Reply to Reviewer Comments

Reviewer 1:

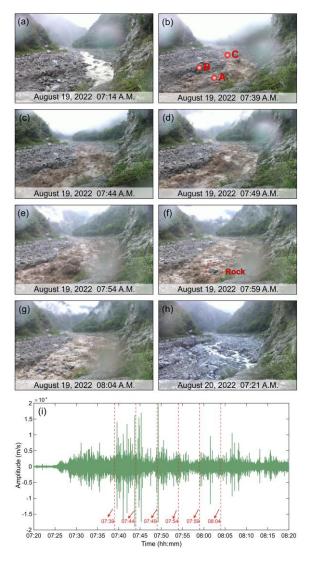
C2: Definition of the quantified characteristics of the debris flow that will be estimated from seismic signals: velocity, discharge, sediment concentration and granulometry, ...

R2: Thank you for your constructive comments. Obtaining quantified characteristics of the debris flow from seismic signal is the ultimate goal of debris flow seismology, and some researchers have tried to reconstruct the dynamical parameters of the debris flow from the low-frequency information of the large-scale debris flow seismic data observed in the far-field. However, the low-frequency information in the seismic data observed in the near-field is weak (only ultra-large scale debris flow has relatively high quality low frequency signal), and the high-frequency information is too complicated for the inversion to obtain the quantified characteristics of the debris flow. In this research, we still aim to semi-quantitative characteristics analysis of debris flow about its velocity, discharge, sediment concentration and granulometry estimated from seismic signals. We agree with the reviewer, and the quantified analysis is our next research purpose.

The part about velocity, discharge, sediment concentration has been modified in the section "Infrared imagery analysis", as follows:

Analyzing the evolution of the debris flow, we observed a gradual increase in debris flow discharge from 7:39 to 7:59. This increase can be attributed to the relatively high flow velocity during this period, leading to intensified erosion along the course of the rock and soil body adjacent to the accumulation area. As a result, the

fluid-solid phase material content increased, leading to a tendency for the flow rate to rise. At 7:59, the flow velocity decreased to some extent, resulting in weaker erosion. The debris flow gradually transitioned into a state resembling a "flood". In Fig. 7f, point A exhibits a stationary stone block that cannot be moved, and in Fig. 7g, the rock bed becomes clearly visible. These observations indicate that the erosion capability and carrying capacity of the debris flow were weak at this moment. This complex behavior in the trend of flow velocity, discharge, and particle composition changes during the debris flow's evolution underscores the inconsistency in their characteristics. In the next section, we will integrate these variables with the seismic PSD forward modeling of debris flow generation to analyze their respective impacts on the signal. This analysis will provide insights into the contradictory peak time observations between infrared imagery and seismic interpretation.

The infrared images show a gradual increase in the particle content of the debris flow from 7:39 to 7:49, with high particle content maintained between 7:49 and 7:54 but far lower concentrations at 7:59 and 8:04. The debris flow evolution analysis showed flow velocity increased gradually from 7:39 to 7:59, and was relatively high; in this condition, there is intense erosion of accumulations next to the channel and entrainment along the flow path, which increases the proportion of solid phase in the fluid. As flow velocity decreases, erosion weakens and the particle content gradually decreases, turning the debris flow into a water flood. The presence of a rock at point A in Fig. 7f and 7g illustrates the lack of transport capacity at this stage of the debris flow.

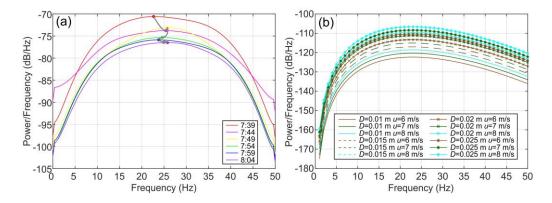
C3: Explanation of how these characteristics are estimated from seismic signals (if I get it correctly, estimation of the PSD from seismic signals to invert for u (and D) in eq 8 + cross-correlation between two seismic stations)

Estimation of the PSD from seismic signals to invert for u (and D) in Eq. (7) is modified, as follows:

Eq. (6) was employed to calculate the seismic Power Spectral Density (PSD) curves for the six-time points corresponding to the infrared images (Fig. 9a). Notably, the maximum energy within the main frequency band (15~30Hz) exhibited a gradual decline from 7:39 to 8:04, evident from the discernible trend in dot changes depicted in Fig. 9a. The width of the PSD spectrum demonstrated an initial increase, followed by a subsequent decrease, showing distinct trends between the low-frequency and high-frequency bands. Specifically, the high-frequency band (>30Hz) experienced a gradual reduction from 7:39 to 8:04, characterized by a rapid decrease from 7:39 to 7:49 and a relatively slower decline from 7:54 to 8:04. Conversely, the low-frequency band (<15Hz) exhibited a substantial increase from 7:39 to 7:44, followed by a more

substantial decrease leading up to 7:54, after which it roughly remained unchanged. These varying characteristics among different frequency bands underscore the need for a deeper understanding. In the subsequent sections, we will employ a debris flow seismic PSD forward model to gain a more comprehensive insight into these observations.

We conducted debris flow seismic Power Spectral Density (PSD) forward modeling (Fig. 9b), employing Eq. (7) with key parameters derived from observations of the 2^{nd} debris flow in Fotangbagou. D was determined based on 94% of the particle size, resulting in values of 0.01 m, 0.015 m, 0.02 m, and 0.025 m, respectively. The velocity u was consistent with the mean velocity described in Section 4.3, which was set at 2 m/s, 4 m/s, and 6 m/s. The seismic propagation distance r_0 was determined by measuring the distance between Point 1 and the central channel of the 2^{nd} debris flow in Fotangbagou gully. All other parameters in Eq. (7) remained consistent with those used for seismic signal recovery, as detailed in Section 4.1.

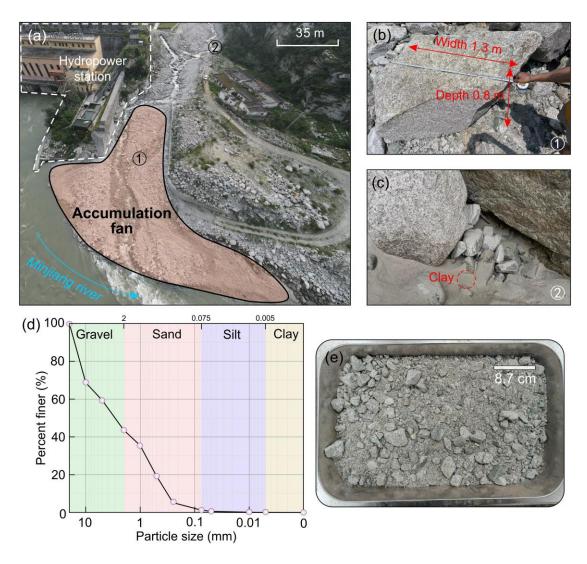
C4: Explanation of how the methodology is validated using a specific debris flow event and other data / methods to estimate the debris flow characteristics (camera footage, post-event field work, ...)

The section "Post-event field investigation" is modified to estimate the debris flow characteristics, as follows:

The field investigation and UAV survey at Fotangbagou Gully started on the third day after the debris flow events, and nearby villagers confirmed the accumulation fans had not been disturbed. UAV aerial imagery of the accumulation fan at the gully mouth and close-ups of surface conditions are shown in Fig. 8a–8c. Field measurements indicate the fan is about 1.2 m thick, with a thin layer (1–2 mm) of clay covering the surface in several areas (Fig. 8c). Some rocks with diameter larger than 1 m in Fig. 8b and 8c show that the debris flow has a relatively high carrying capacity, and the rocks at the bottom of the alluvial fan are relatively large (Fig. 8b), while the rocks in the front part of the alluvial fan (Fig. 8c) are relatively small, indicating that the carrying capacity of the debris flow sharply decreases after it is released from the channel constraints (or in other words, the cross-sectional area increases).

A sediment sample was collected from the accumulation fans in the Fotangbagou gully to estimate the particle size distribution of the debris flow. The sample (Fig. 8e) of about 4.7 kg was taken around the location marked ① in Fig. 8a. Grain size analysis was undertaken by sieving and a Malvern particle sizer. Due to lack of several sample analysis in this study, we should consider finishing several sample

analyses to estimate the variability in other researches. We forgot to record the fraction of materials that was above the maximum particle size displayed in the granulometric curve. Thus, we should finish it in other similar researches. The results show that clay, i.e., particles with grain size less than 0.005 mm, accounted for only 0.041% of the total weight of the sample from the channel (Fig. 8d), which is consistent with field observations. The low cohesive sediment content of the accumulation fan sample could be due to removal by post-event processes, either by the flushing action of the Minjiang River or by human clearance of the impoundment fan. The particle size distribution shows that 94% of the particle size of the sample is 0.018 m, i.e., *D* in Eq. (7). In the next section, we will use *D* as a guide for forward analysis of the PSD curve features of the debris flow.

Fig. 3. Research methodology for processing and analysis of debris flow seismic signal.

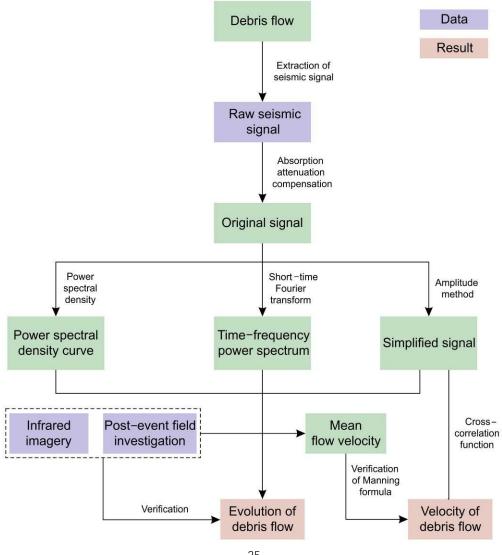
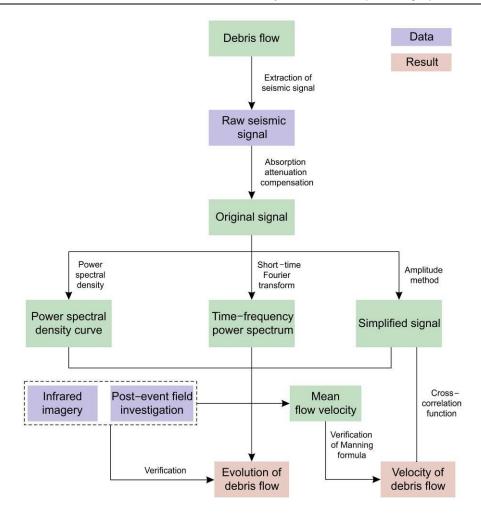
C16: The workflow is not clear in Figure 3. If I understand well, the "absorption attenuation compensation" (consider changing the name to simply "attenuation compensation") depends on the frequency, so you need to apply the STFT first. Besides, the PSD is deduced from the time frequency power spectrum, so the correct workflow should be, if I understand well, as in the following graph. The order of subsection in the Methodology section should reflect this ordering. Finally, if I'm correct you do not explain what the "amplitude method" is and what the "simplified signal" is.

C81: Figure 3: "Infrared imagery" only during the night! For "amplitude method" and "simplified signal", it is not clear what it corresponds to in the methodology presented in the main body of the article. Don't you estimate the maximum flow velocity from the seismic signal also? Be more specific when you mention "scale of the debris flow", do you mean discharge? Volume? See also the first specific comment for the Methodology section.

R16: Thank you for the constructive advice. Actually, power spectral density curve, time-frequency power spectrum, simplified signal are obtained based on original signal, which differs from your workflow. We acknowledge the workflow is not clear to make you confused, so the workflow of Fig. 3 has been modified into the following graph after we changed the structure of the manuscript. And we start the section Methodology with a brief systematic introduction to this section to facilitate the reader's understanding of our Methodology. This part has been modified, as follows:

To extract information on debris flow evolution, debris flow seismic signals were processed and interpreted by following the procedure in Fig. 3. Absorption attenuation compensation is first to be processed for each frequency of the extracted seismic signal of debris flow to restore the different energy loss caused by different propagation, which was aimed to obtain the seismic signal of debris flow that is not affected by sensors installation location. Then, the seismic spectrogram is from compensated seismic signal based on short-time Fourier transform, characteristic analysis of debris flow evolution has been done by computing power spectral density of keyframe and the absolute value of time-domain amplitude, the evolution analysis result has been verified based on infrared imagery and post-event field investigation. Finally, the maximum velocity of debris flow has been estimated by computing the absolute seismic amplitude of different monitoring stations based on the crosscorrelation function, which has been verified by the Manning formula. The key steps are outlined below in Fig. 3. Amplitude method in this figure is used to get the absolute value of time-domain amplitude in this figure. After this method, the signal processed by us is called a simplified signal.

To extract information on debris flow evolution, debris flow seismic signals were processed and interpreted by following the procedure in Fig. 3. Absorption attenuation compensation is first to be processed for each frequency of the extracted seismic signal of debris flow to restore the different energy loss caused by different propagation, which was aimed to obtain the seismic signal of debris flow that is not affected by sensors installation location. Then, the seismic spectrogram is from compensated seismic signal based on short-time Fourier transform, characteristic analysis of debris flow evolution has been done by computing power spectral density of keyframe and the absolute value of time-domain amplitude, the evolution analysis result has been verified based on infrared imagery and post-event field investigation. Finally, the maximum velocity of debris flow has been estimated by computing the absolute seismic amplitude of different monitoring stations based on the crosscorrelation function, which has been verified by the Manning formula. The key steps are outlined below in Fig. 3. Amplitude method in this figure is used to get the absolute value of time-domain amplitude in this figure. After this method, the signal processed by us is called a simplified signal.

Fig. 4. Cross-sections of Fotangbagou gully showing maximum water level used in calculation of mean velocity by the Manning formula. (a) Monitoring station 1; (b) Monitoring station 2.

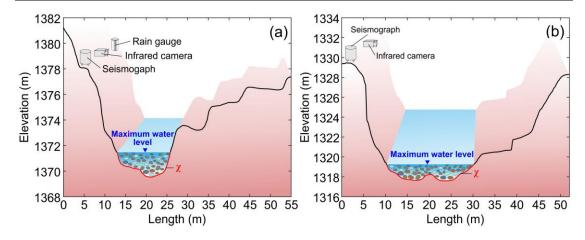
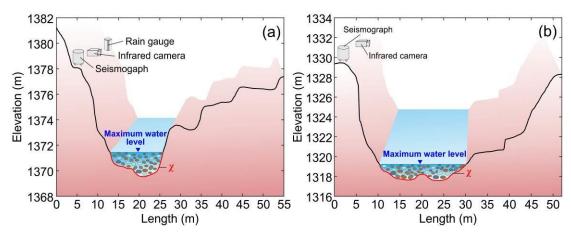
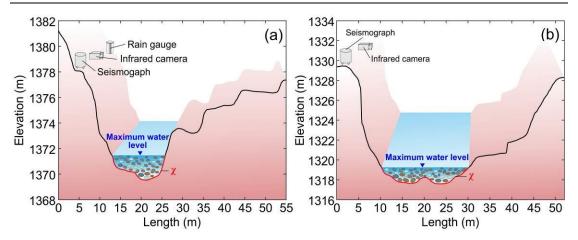
C24: 1.231-232: You must explain more clearly what J and R are, explain how you compute them, and illustrate it on a figure (e.g. on current Figure 13 that could be placed in section 3.3).

C66: 1.605: What is the wet perimeter?

C89: Figure 13: This figure should be in the Methodology section, and should be improved to illustrate how the different parameters of the Manning formula are computed.

R24: We deeply appreciate the reviewer carefully went through the manuscript line by line. Section 3.3 has been modified, as follows:

To verify the reliability of the velocity calculations based on the cross-correlation function, mean velocity was also determined using the Manning formula (Eq. (5)), which was originally developed for hydraulics problems (Rickenmann, 1999). The formula is used to calculate the mean flow velocity of a debris flow passing through a section based on characteristic terrain parameters of the section (Yu and Lim, 2003; Cui et al., 2013; Guo et al., 2016):

R66: Thank you for the useful advice. χ can be used to estimate summation of bed length and lateral depth of the channel wetted by debris flow in the cross-section. The sentence above has been modified in Section 3.3. The definition of the wet perimeter is shown in Fig. 4.

R89: Thank you so much for the comments. This figure has been moved to the Methodology section and added illustration of wet perimeter χ . It has been modified, as follows:

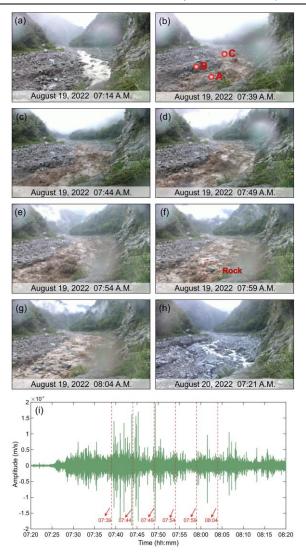
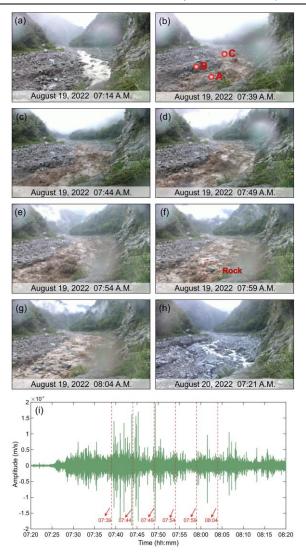
C49: 1.412: We cannot see the rock you mention in Figures 8e and 8f, and we cannot say if it was present before or not.

C85: Figure 8: Picture are very small, it is difficult to see the different behaviours of the debris flow at each time.

R49: Thank you so much for the comments. In order to support this result, we offer a pre-event, post-event imagery of the channel monitored by an infrared camera, respectively, which is shown in Fig. 7a, 7h.

R85: Thanks a lot for the constructive comment. Pictures have been arranged to improve their clarity. It has been modified, as follows:

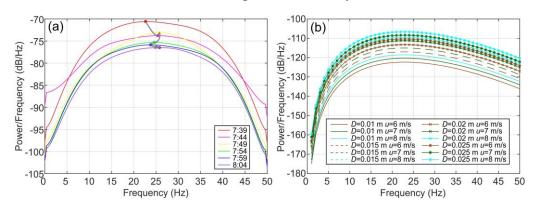
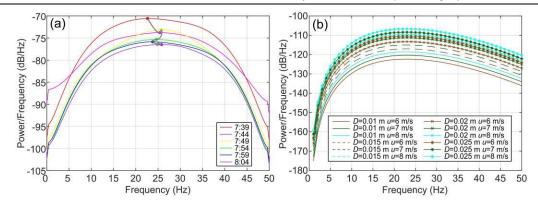
C55: 1.447 to 457: Figure 10 does not illustrate very well what you say in this paragraph, especially the temporal variations you mention. A plot with the temporal variations of the PSD would be more appropriate.

C87: Figure 10: This plot is not easy to interpret. It must be improved / changed to better illustrate and support the statements made in the main body of the article. L.463 you mention "PSD maximum", it is not clear what this maximum corresponds to (maximum over what?).

R55: Thanks a lot for the constructive comment. We will follow your constructive suggestion if we choose video to monitor debris flow subsequently. Because we used camera with 5-min interval shooting, it is better to draw a plot with the frequency variations of the PSD to achieve semi-quantitative analysis of PSD.

R87: We thank the reviewer for this helpful comment. This figure has been divided into two figures. It would make the figures easy to interpret. It has been modified, as follows:

Fig. 1. Overview of the study area. (a) Location of the study area within China; (b) The two study catchments, Ergou and Fotangbagou, on the Minjiang River, Wenchuan, Sichuan, China.

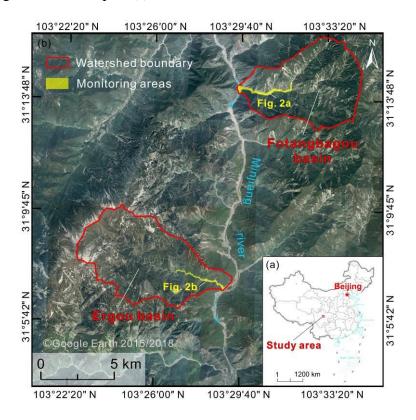
C79: Figure 1: You should simplify the legend, especially as some labels are repeated (e.g. Granite). Consider adding a topographic map. The insert (a) is small and the satellite imagery is visible behind, you should improve that. Explain in the legend what the yellow lines are.

R79: Thank you so much for the comments. We have changed size of subplot (a) and (b) to solve the problem mentioned by you in this figure. Two topographic maps were added in Figure 2. The subplot (c) has been deleted. It has been modified, as follows:

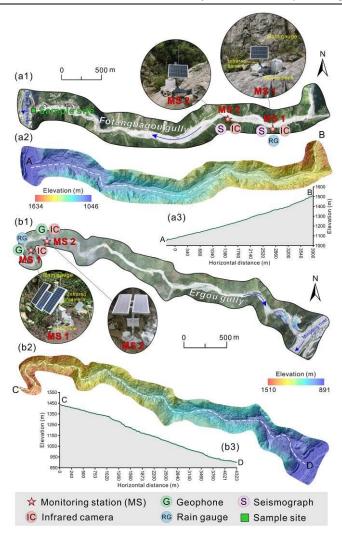
C80: Figure 2: I'm not sure a picture of all stations is necessary. You should add a Digital Terrain Model map for the two gullies if you have one. A longitudinal profile could also be helpful.

R80: We thank the reviewer for this comment. We have added two Digital Terrain Model maps for the two gullies. It has been modified, as follows:

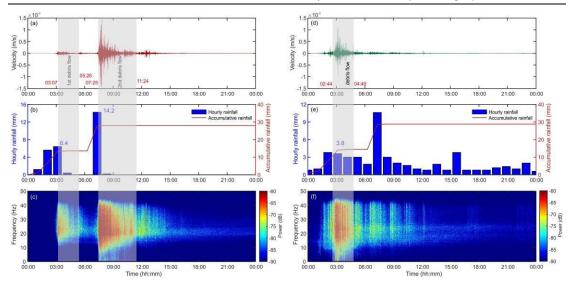
C82: Figure 4: You should display the alleged start and end time of all three events to improve clarity. In a and c, the high amplitudes exceed the plot limit. Is it only a representation issue, or is the signal saturated? In the legend of (a), you say that there's only the second debris flow, but aren't there two?

C83: Figure 5: You could add the seismic signals in the background, or at least the beginning and end time of all three events. The link with the precipitations would be more apparent.

R82: Thank you for your constructive comments. The alleged start and end time of all three events have been added in this figure. It is representation issue for the high amplitudes to exceed the plot limit. There is an error in the legend of (a), it has been modified into "raw seismic from Fotangbagou gully debris flow at station 1". It has been modified, as follows:

R83: We totally agree with the reviewer's suggestion. This figure has been combined with Figure 4 in the first version. The beginning and end time of all three events have been added in the figure.

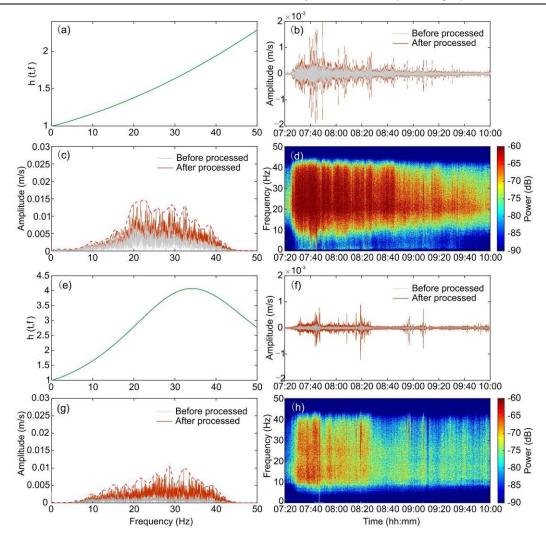
C42: Figure 6: Why is there a maximum for the damping factor in Fig 6e and not 6a?

C84: Figure 6 and 7: Figure 7 use elements already present in Figure 6. Thus I would only display the damping factor and PSD in Figure 6. The "simplified signal" could also be displayed in Figure 7a and 7b. In the legend of Figure 6d, I think it is station 1, not station 2.

R42: Thank you for your professional comment. Parameters in h(t,f) are different for the two stations, which caused the curve change of h(t,f) are different for the two station. Thus, there is a maxima for the damping factor in Fig 6e and not 6a.

R84: Thank you for your professional comment. Figure 7 in the first version has been deleted because this figure has appeared in Figure 6 in the first version. In the legend of Figure 6d, it is station 1, it has been modified into "Time-frequency domain energy spectrum for monitoring station 1". It has been modified, as follows:

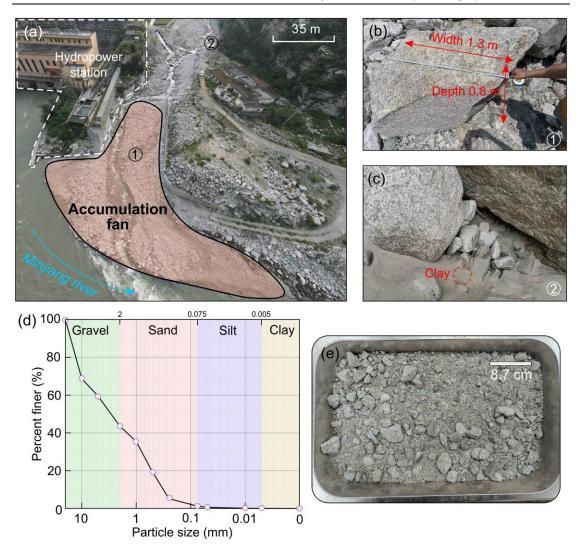
C86: Figure 9: "viscous particle" is not an appropriate term. In (d), you could add the granulometric ranges associated to gravel, sand, silt and clay.

R86: Thank you for the useful advice. "Viscous particle" has been modified into "clay". Range of gravel, sand, silt and clay has been added in subplot (d). It has been modified, as follows:
